Technical Service Bulletin

GROUP**BODY ELECTRICAL****NUMBER****26-BE-016G****DATE****JUNE 2026****MODEL(S)****G70 (IK)****SUBJECT:**

FRONT PARKING DISTANCE WARNING (PDW) SENSOR FALSE DETECTION

Parts Improvements:

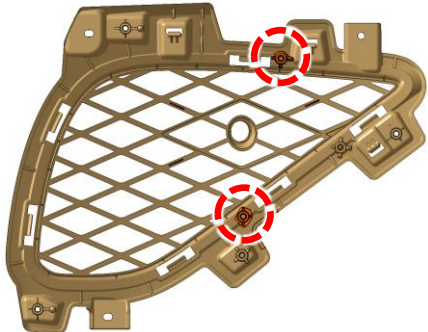
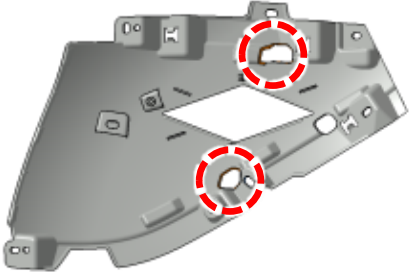
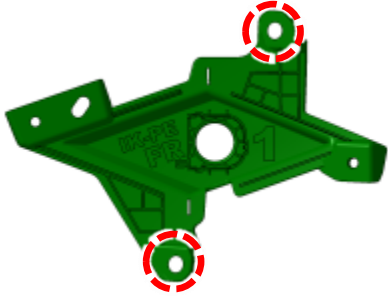
Grille – Front Bumper Side	End Piece	Sensor Holder

2 mounting screws added	2 holes for mounting screws added	2 holes for mounting screws added
